Agenda
Zoning Board of Appeals
Council Chambers
Wednesday, September 28, 2016 - 7:00 P.M.

Staff Review of Zoning Interpretation Application
908 Pleasant Drive

Staff Review of Variance Application
905 Hillside Ct Carport
905 Hillside

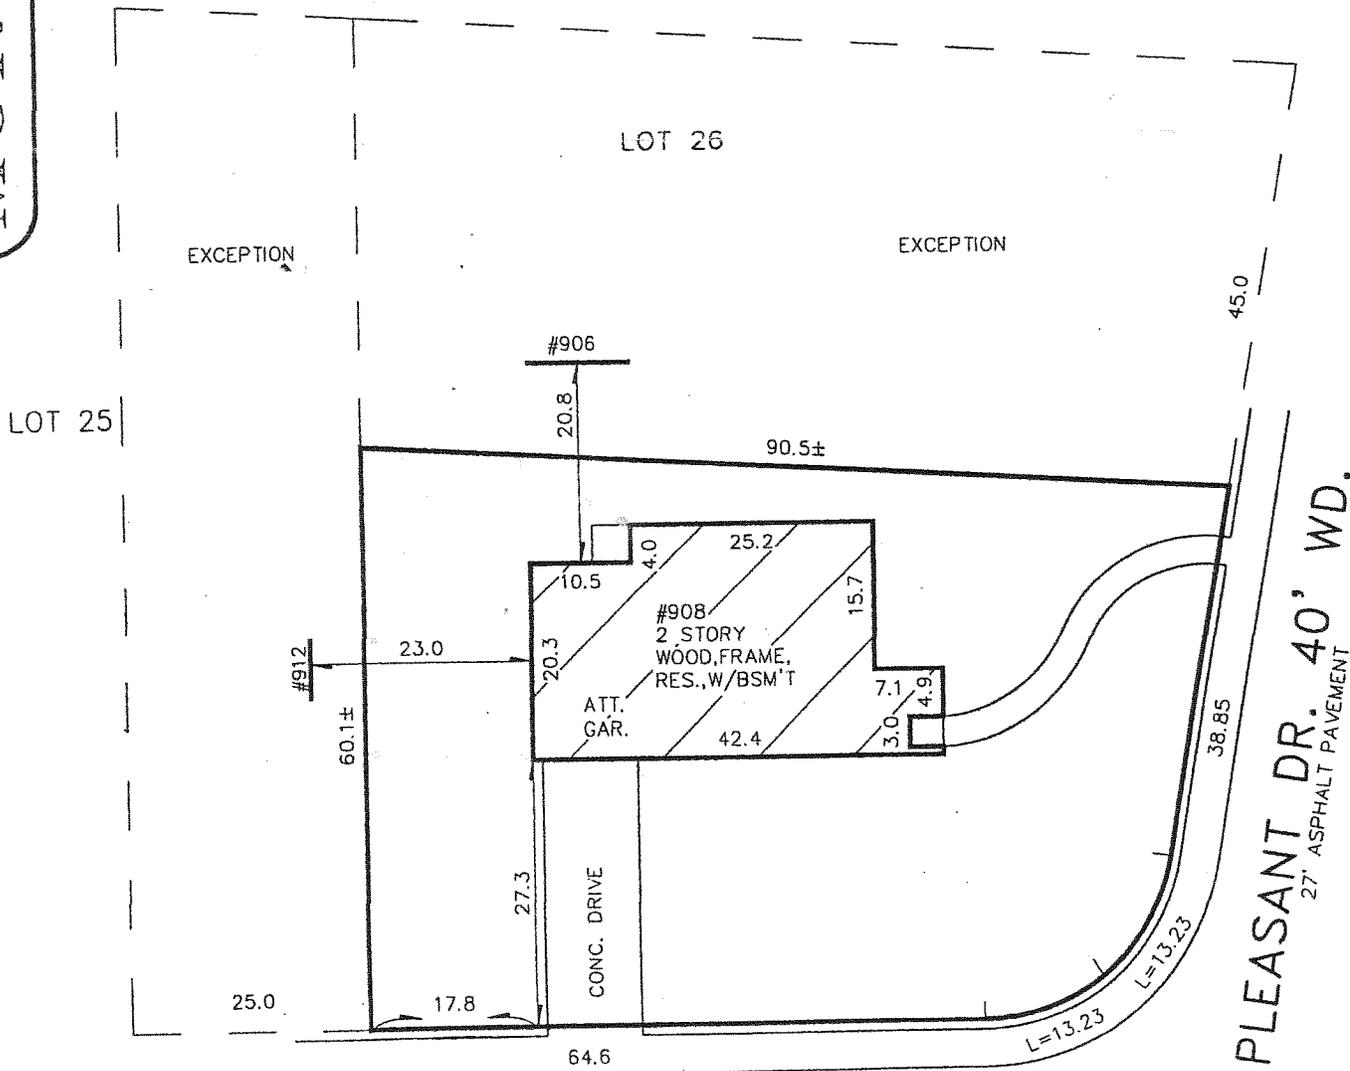
The applicant has provided a mortgage survey, which shows the south setback to be 27.3 feet and the west setback to be 17.8 feet; north and east setbacks are not shown. On the city's aerial, which has a significant margin of error, they appear to be 24 feet to the east and 8 feet to the north, at the narrowest points. Per the zoning ordinance in effect at the time of construction,

Figure 5: Proposed Setback (0.2' from north side property line)

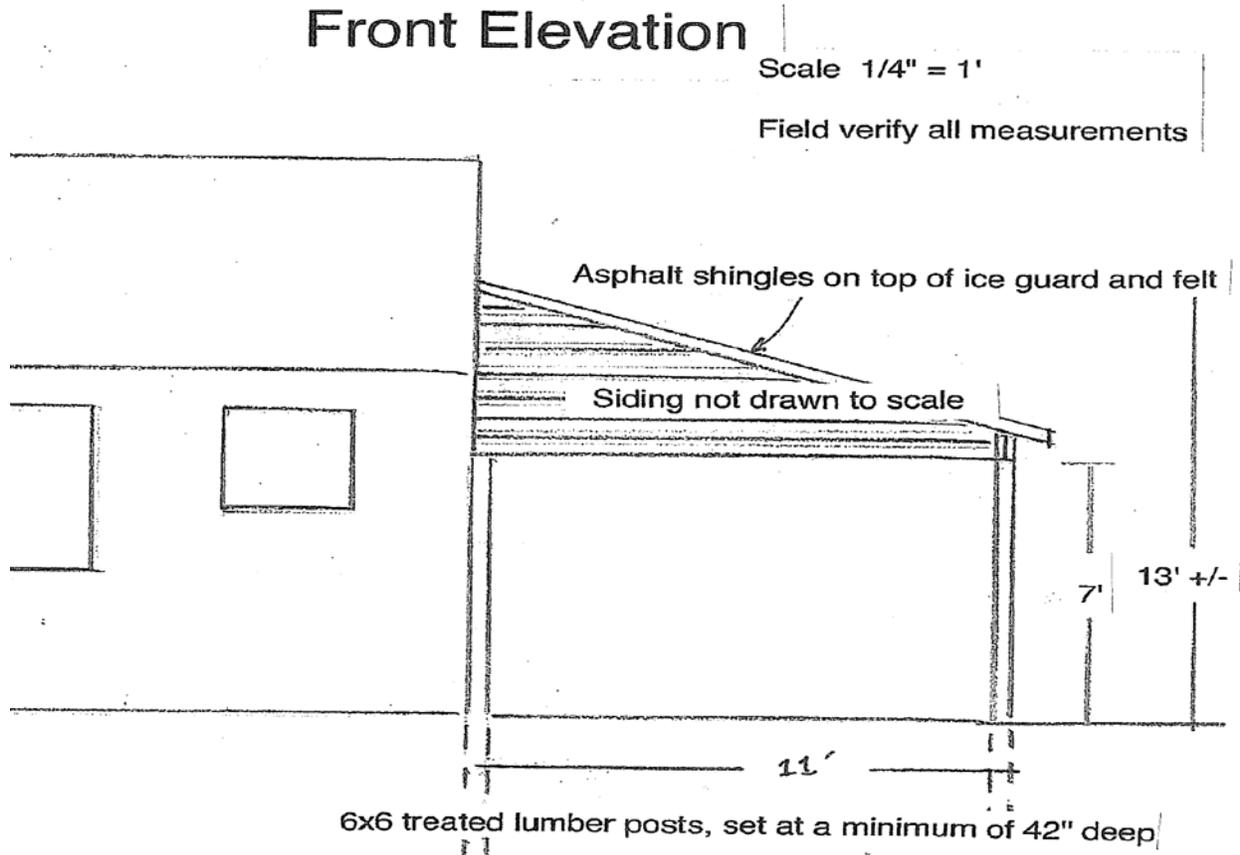
The *application* submitted indicates that the post for the carport will be set 6" from the property line, with no mention of eave overhang. The *drawings* submitted indicate a carport width of 11'; as the house is only 11.2' from the property line, that would leave approximately 2.4" between the post and property line, not the 6" claimed. Furthermore, the post sizes are inconsistent between the quote (4x6) and the drawings (6x6), and the measurement is not marked as being on center or edge to edge, making the precise request difficult to determine, as well as whether and how much the eaves of the carport would encroach onto the

Glass carport construction at **905 Hillside Court**

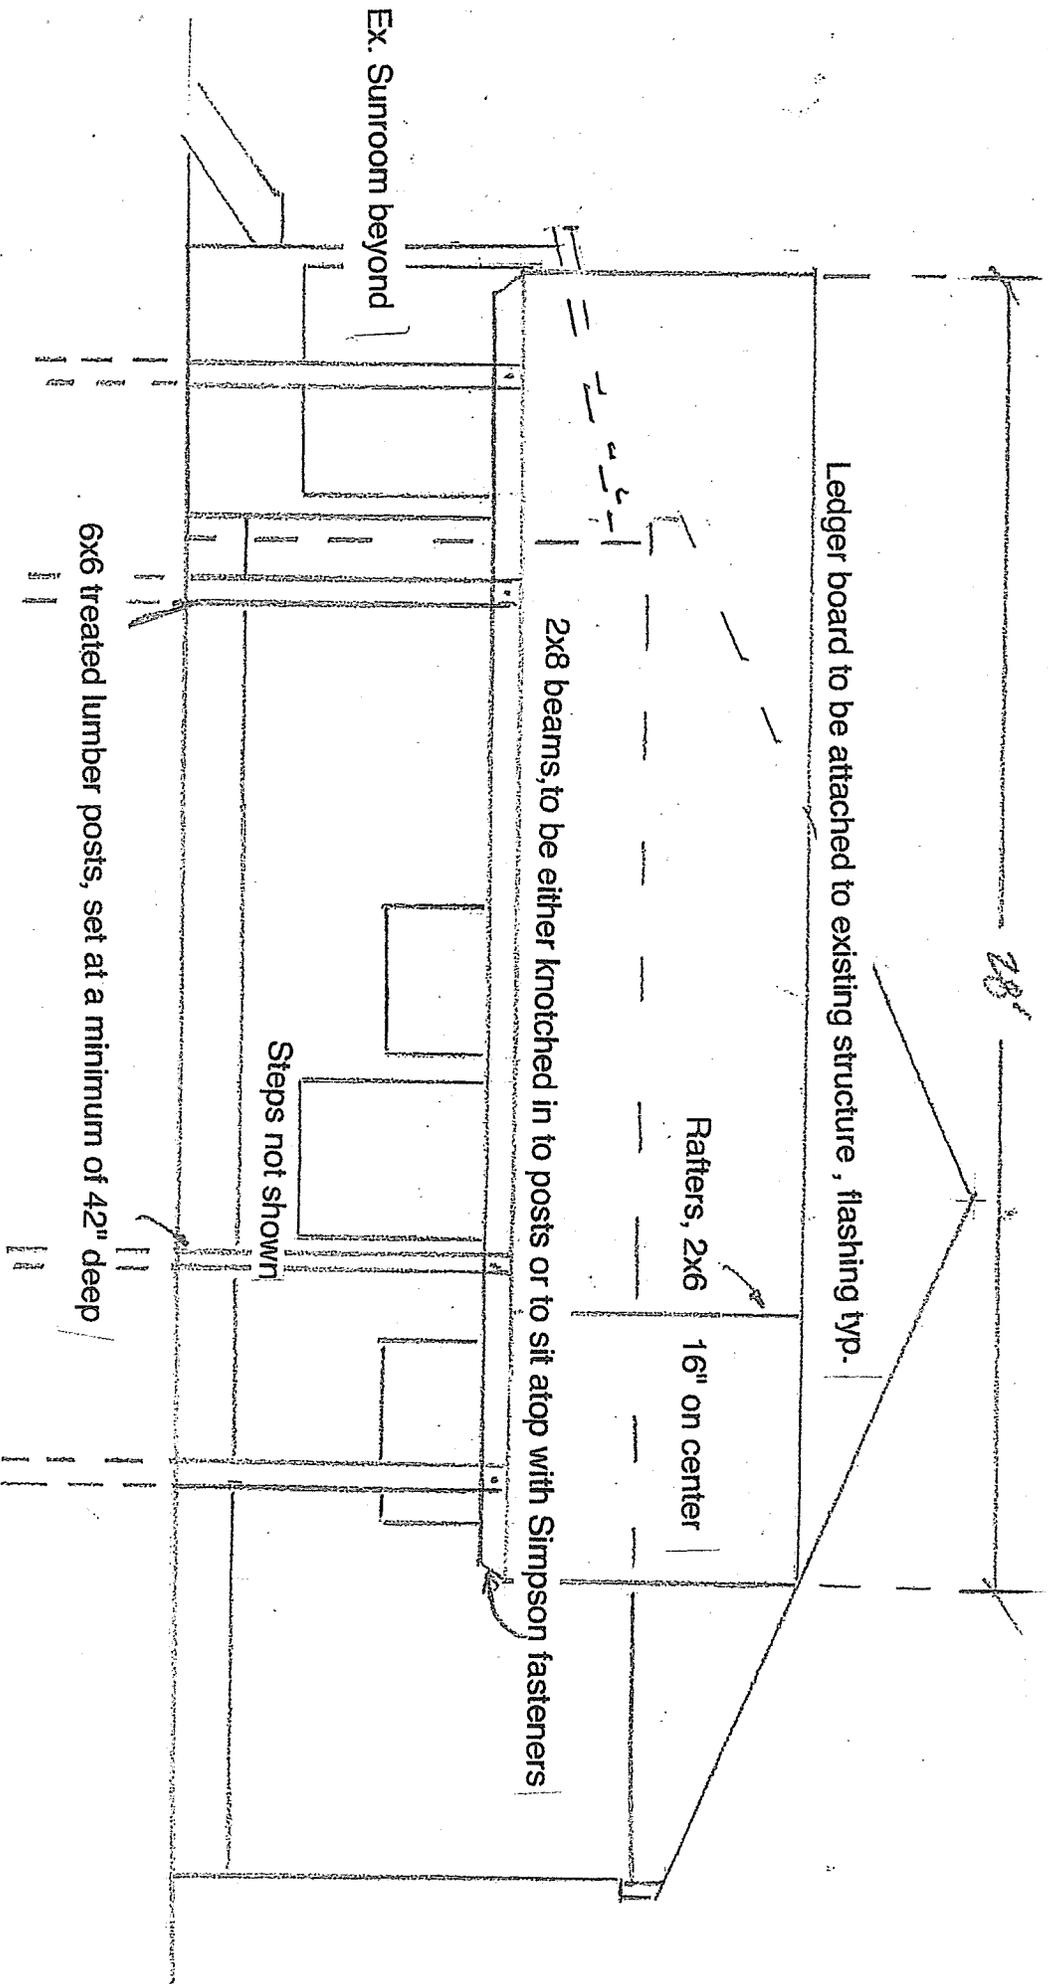
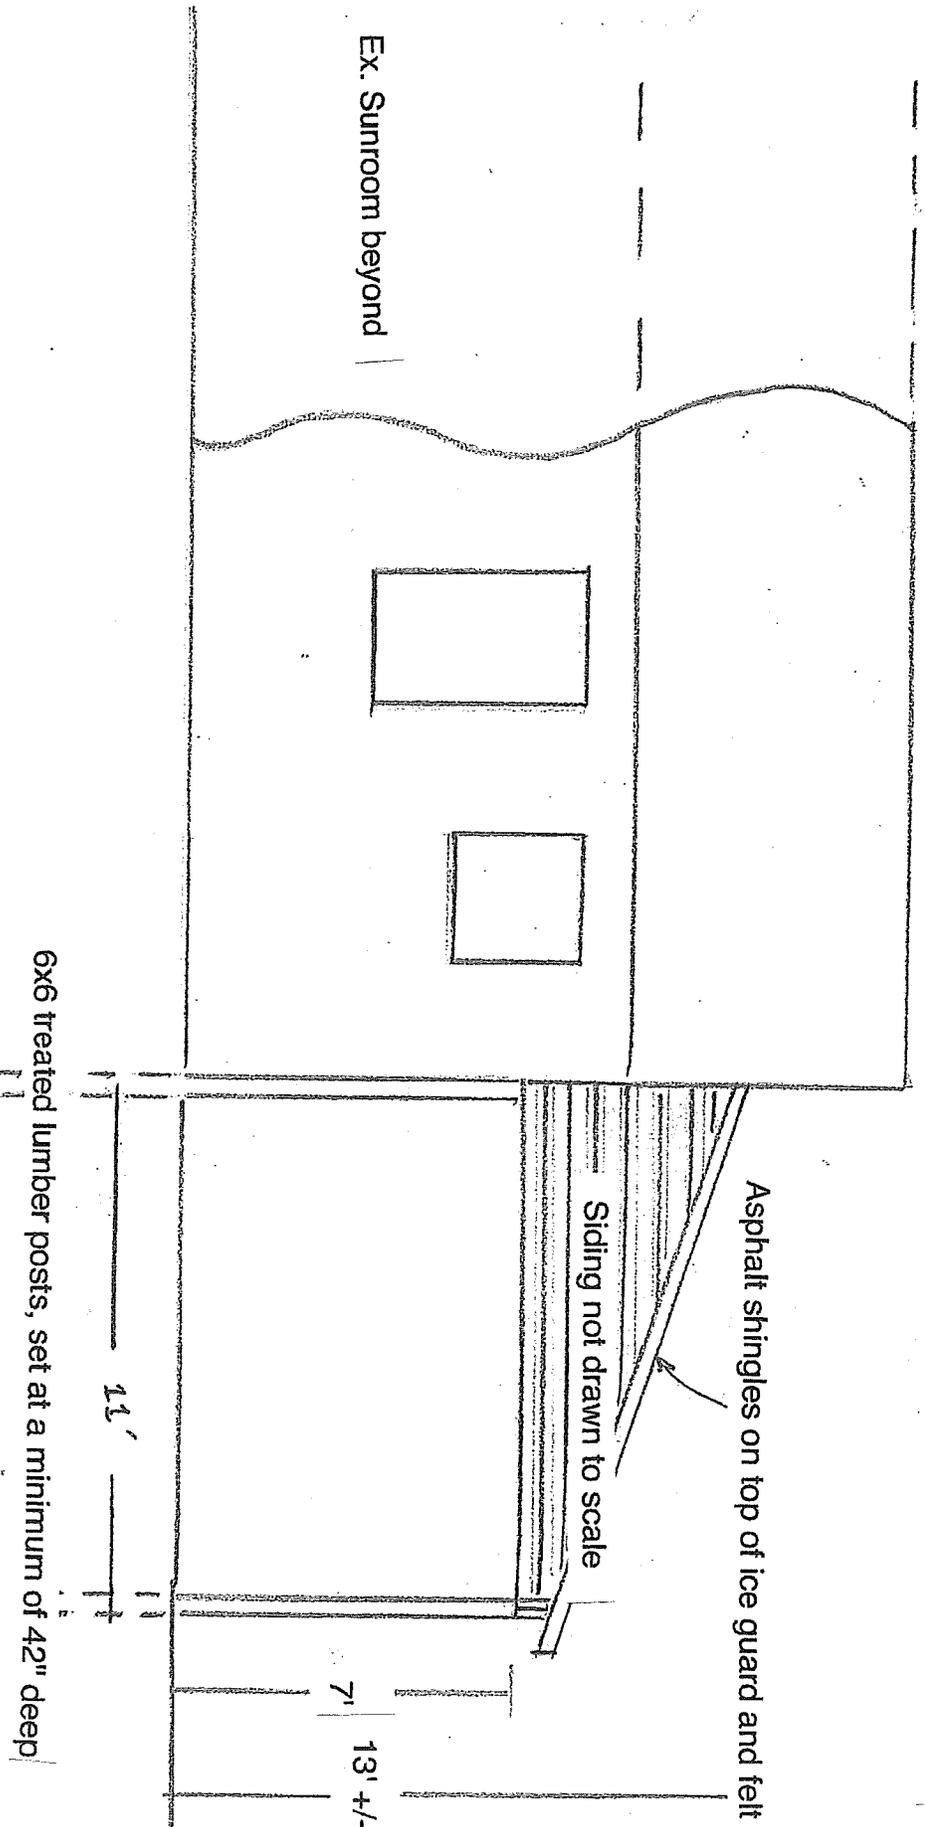
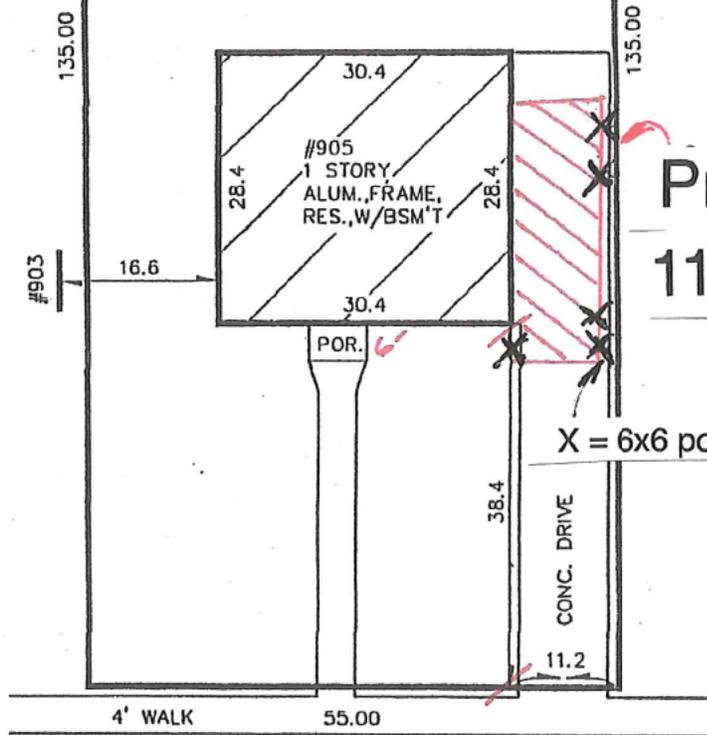
neighboring property. In addition, as drawn, a full size vehicle will not fit entirely under the carport front-to-back with the existing entrance. An exact height for the carport is not indicated. The applicant should also note that fire-rated construction may be required.

The stoop is not indicated on plans for an exact measurement, however, we estimated that there is less than 6 feet clearance in the driveway adjacent. The space is indeed too narrow for most cars to pass. However, the space east of the entrance is also too shallow for a standard-size vehicle. By way of reference, the City requires that a parking space be at least 9' wide and 18' deep; the carport does not provide 18' of coverage east of the side entrance. It is unclear that this carport will be sufficient to meet the needs of the applicant. Between the location of the side steps and the grade in the rear; staff believes there is sufficient practical difficulty shown, however, the proposed carport does not appear to meet the expressed need.

The carport as submitted may be injurious to the neighboring property. The eave on the carport appears that it will go beyond the property line, encroaching on the neighboring property. Also, the roof may end up shedding snow and ice onto the neighbor's driveway. This standard is not met.

A carport on this side of the home may indeed be the minimum way to obtain covered vehicle storage on this lot in a way consistent with other homes in this neighborhood. However, due to the lack of precision and clarity on the drawings, the minimum variance required to permit a functional carport is difficult for staff to determine. This standard is not met.

Staff recommends the Zoning Board of Appeals *postpone* the variance request to permit a carport to encroach on the side yard setback, as submitted on August 22, 2016, with findings that

- the application does not show clearly and accurately the construction of the proposed carport in accordance with 122-94(a),
- that granting the variance would be injurious to adjacent property owners under 122-94(b)(4);
- that substantial justice will not be done under 122-94(b)(5);
- and that the requested variance is not the minimum to make possible a reasonable use of the property under 122-94(b)(6).
